**REGULAR BOARD MEETING
AGENDA PACKET**

SEPTEMBER 15, 2025

Regular Board Meeting - Monday, September 15, 2025, 6:00 p.m.

**Carmichael Water District Board Room
7837 Fair Oaks Boulevard
Carmichael, CA 95608**

W-4

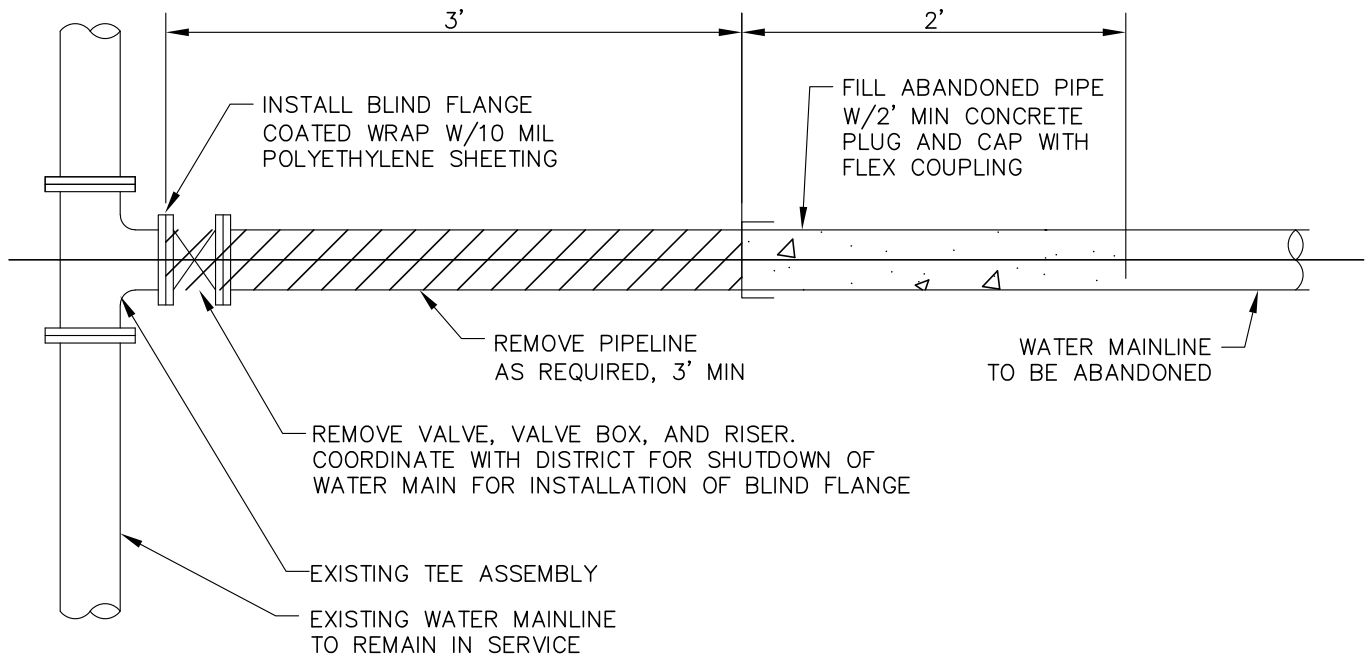
- Detail W-4: Redrew the mechanical joints on the pipe fittings. Revised Note 1. to reference the CWD Construction Improvement Standards.
- Detail W-6a: Changed detail name to W-6 (since W-6b has been archived). Removed “Case ‘C’” as it is no longer used. Changed Note 7. from referencing Detail W-6b to refer to the Construction Improvement Standards instead.
- Detail W-6b: Has been archived as it is out of date and no longer useful.

TYPICAL GATE VALVE & BOX INSTALLATION

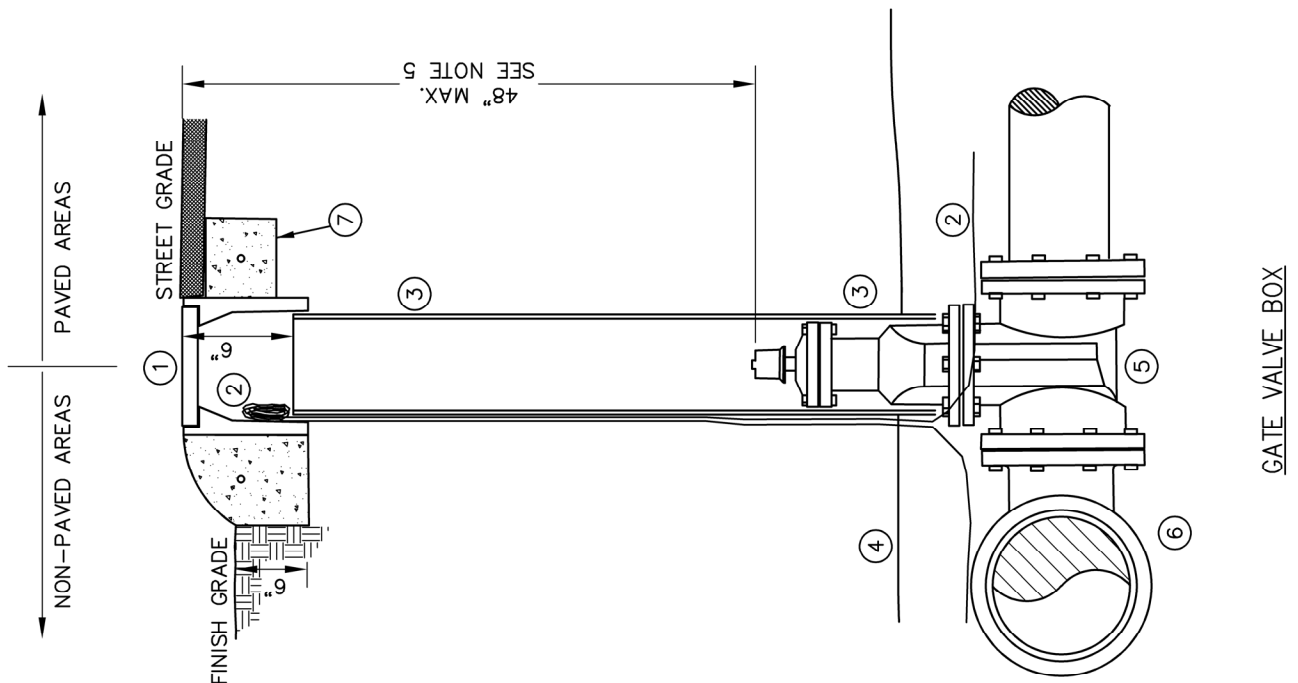
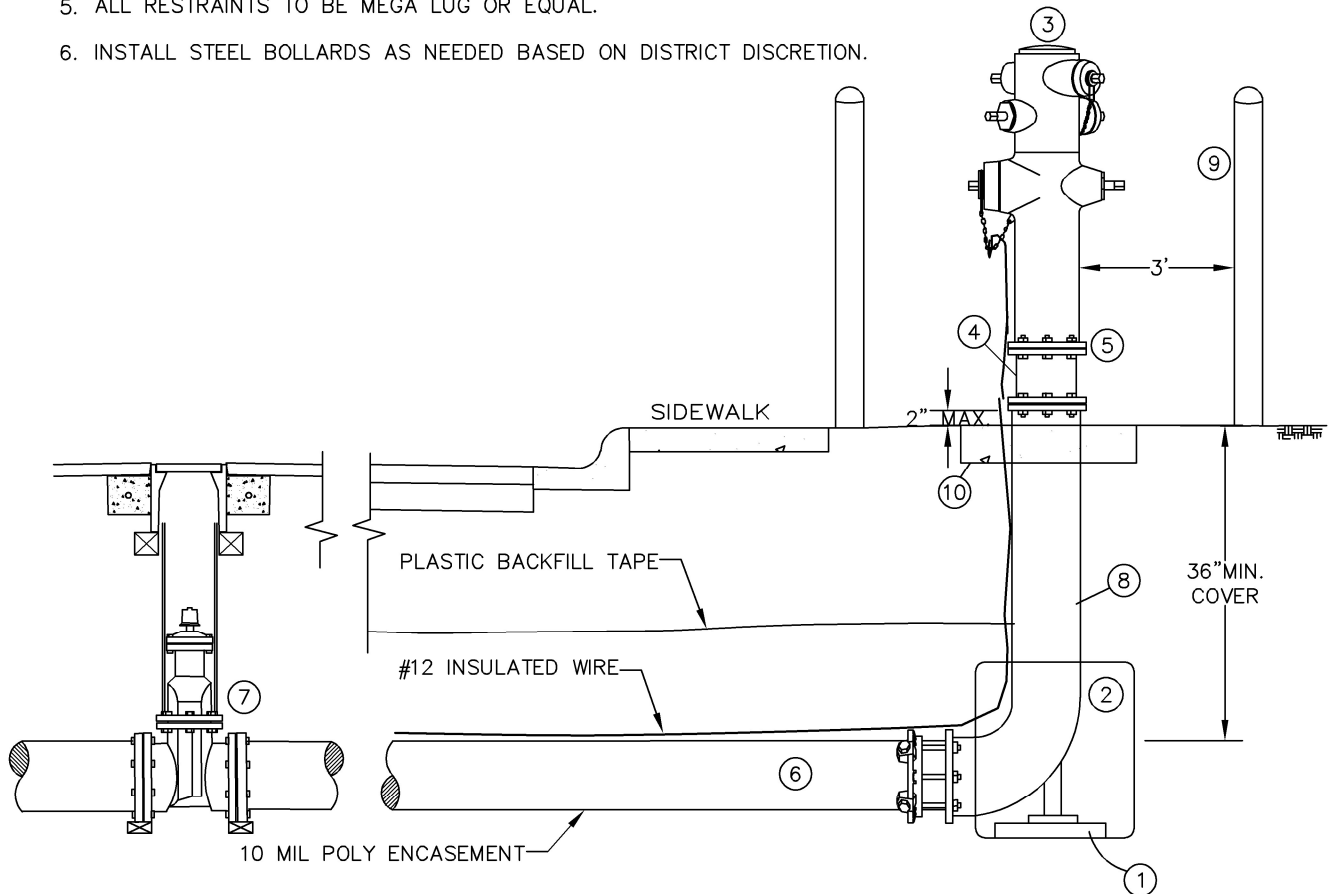
- Detail W-11 Valve Box Detail: Rebar added to the concrete collar, notes and material revised to show the rebar and material change to polymer concrete Hubbell G5 box and lid.

WET BARREL

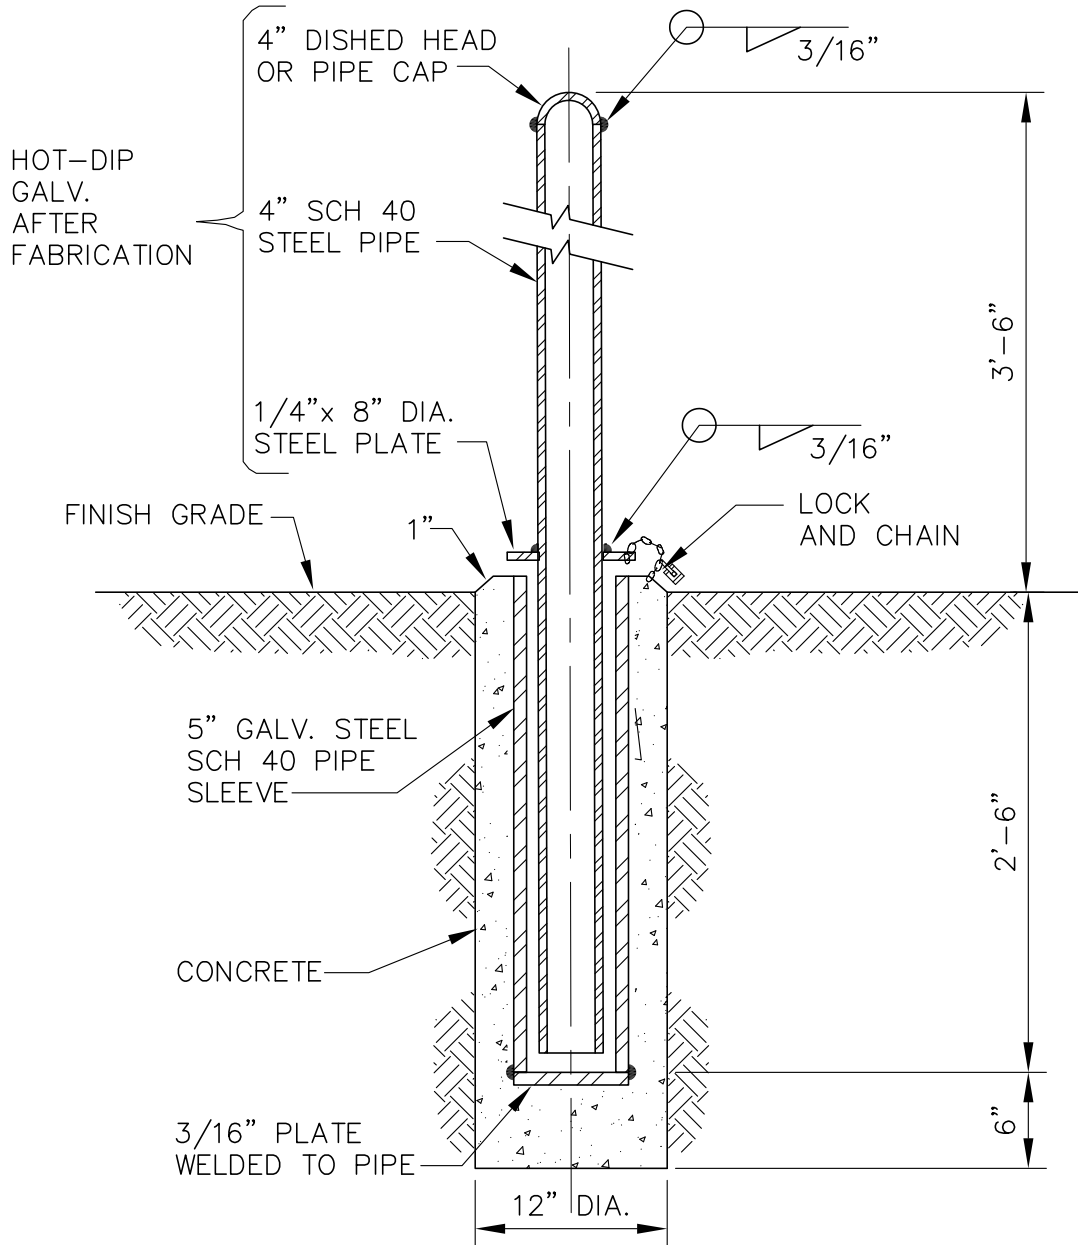
- Detail W-12: The hydrant bury is extended 2" maximum passed the concrete pad, and the check valve has been further specified to be Hydrant Guard (or equal). Materials note 4 revised to call out Hydrant Guard. Materials note 5 revised to call out breakaway bolts. Materials note 10 revised to remove the term "hold bury" from concrete pad description.
- Detail W-21: Before this update was for Typical Service Saddle Installation for 2" or greater service connection, 1" service connection, or ARV tap into the water main. District staff has

- Detail W-12: Fire Hydrant Assembly Wet Barrel: Removed “Dry Barrel” from detail name and edited Note 3 regarding valve placement. Added “Clow 960 or Equal – yellow” to fire hydrant material type. Added Note 6. to advise that bollards are only required per District discretion.

1" & 2" AIR RELEASE VALVE ASSEMBLY

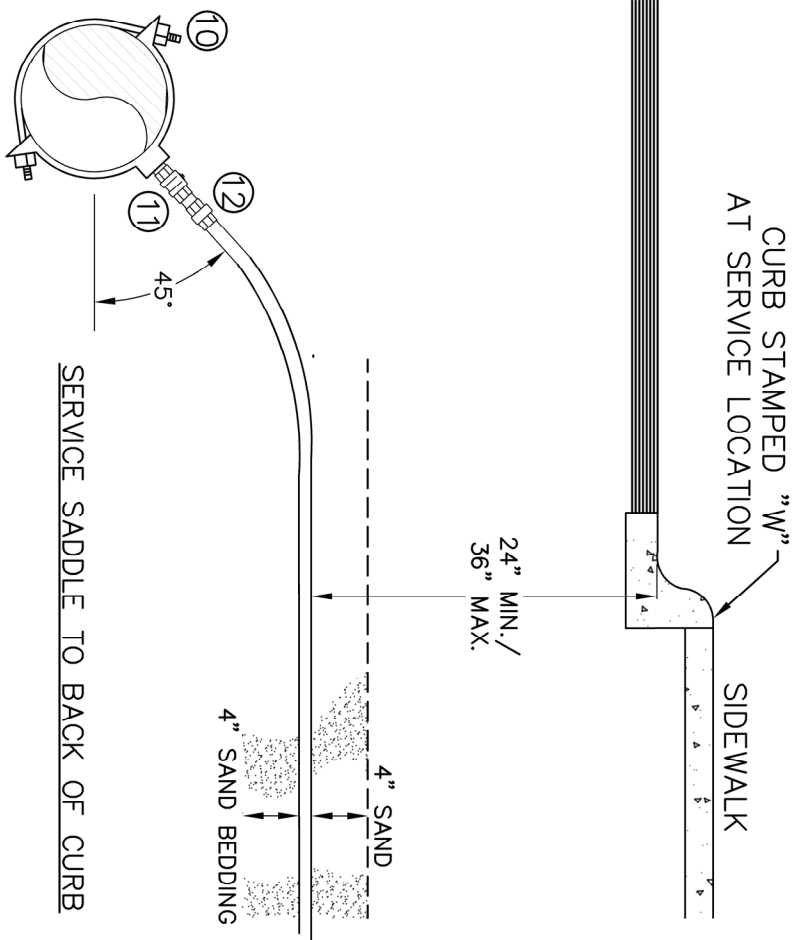
- Detail W-16 ARV Assembly: Detail revised to include the saddle tap into the water main. Added a structural channel support to assembly detail for the ARV, adjusted the fittings and connections for brass to copper and copper to brass configurations. Added a 2" gate valve, riser, and valve box for shut off access at the main. Removed ball valve shutoff that was inside the ARV box before.

- Detail W-16: 1” & 2” Air Release Valve Assembly: Redrew the utility box to match Placer Water Works Inc. utility box type which includes an air vent enclosure. Edited detail notes regarding material types to match new standards.

STANDARD 1" SERVICE CONNECTION

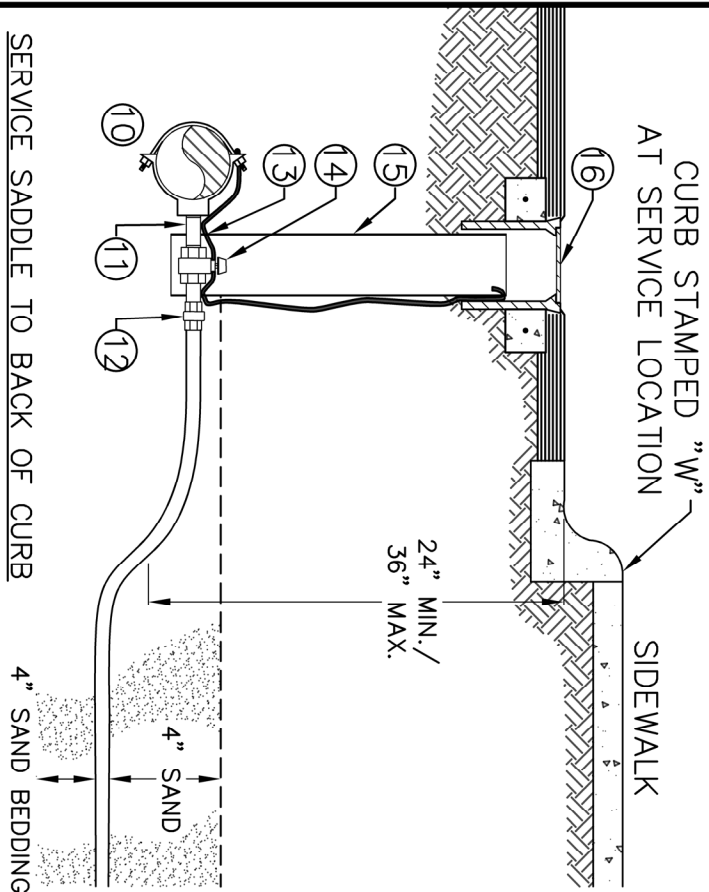
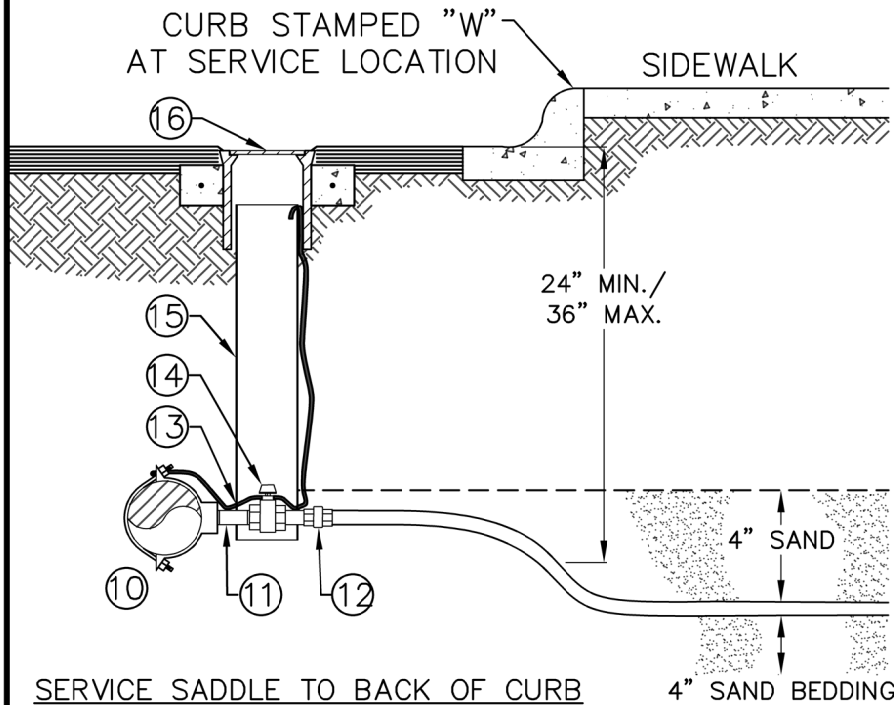
- Detail W-21: Detail W-22 for service/meter box was combined with the service saddle detail (for 1" tap) to now be a 1" SERVICE CONNECTION detail, showing the service saddle and meter box installation requirements in one detail.

- New Detail W-21 and W-22 changes to the meter box requirements include a gate valve on the customer side of the meter, and a brass nipple going out of the box on the customer side for the connection of the customer side water line.

- Detail W-21: Typical Service Saddle Installation: Changed material 1. from “Class 52” to “Pressure Class 350” Ductile Iron Pipe. Removed “Services with continuous copper pipe” from Note 2.

STANDARD 2" SERVICE CONNECTION

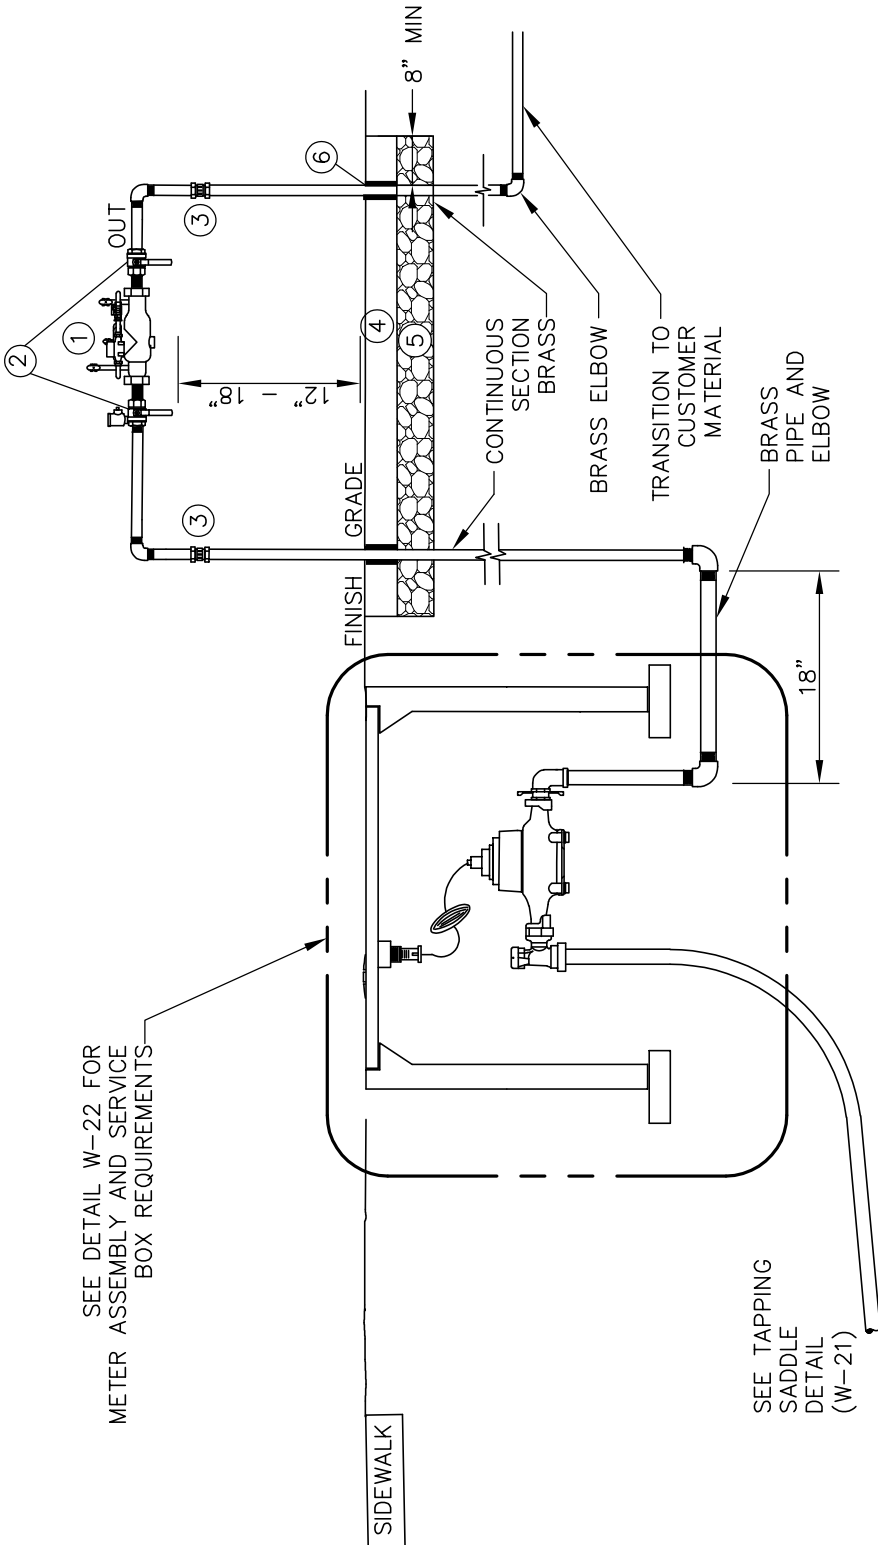
- Detail W-22: Is now going to be 2" SERVICE CONNECTION detail, which has a different tap configuration into the water main. The tap is made at a 90-degree angle rather than 45 degree (1" tap) and a 2" gate valve, riser, and valve box is installed at the main (in street) for shutoff access.

**1" & 2" SERVICE LINE
WITH RP STYLE BACKFLOW**

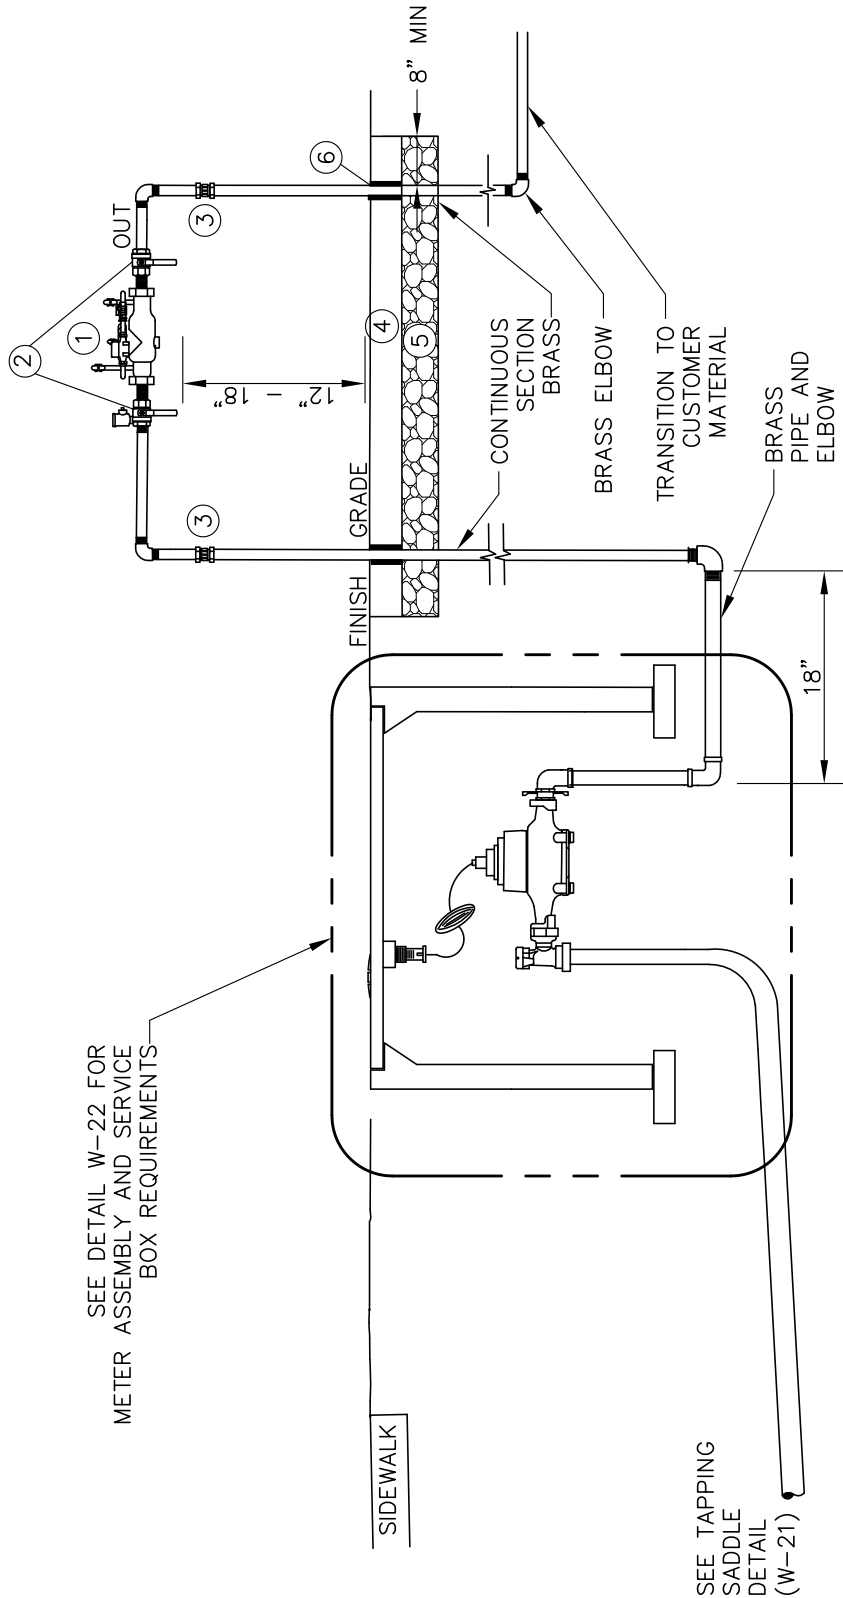
- Detail W-23: Removed Materials note 7 for the concrete support pad under the backflow device lateral piping. Added a callout note indicating brass elbow and a callout indicating brass pipe connecting the meter to the backflow device piping. Removed "3/4" and 1-1/2" Service Line (sizes) from the detail title.

- Detail W-23: 3/4”, 1”, 1-1/2”, & 2” Service Line with RP Style Backflow: Changed detail notes for utility box location and backfill material type.
-
- Detail W-2a: There is a note in this detail for a Sacramento County requirement for grinding pavement at the trench edge down 1 ½”, and the County plans on changing the requirement to 2” in the near future. At the time when the requirement is changed CWD will update this detail to read 2” per the requirement.
-
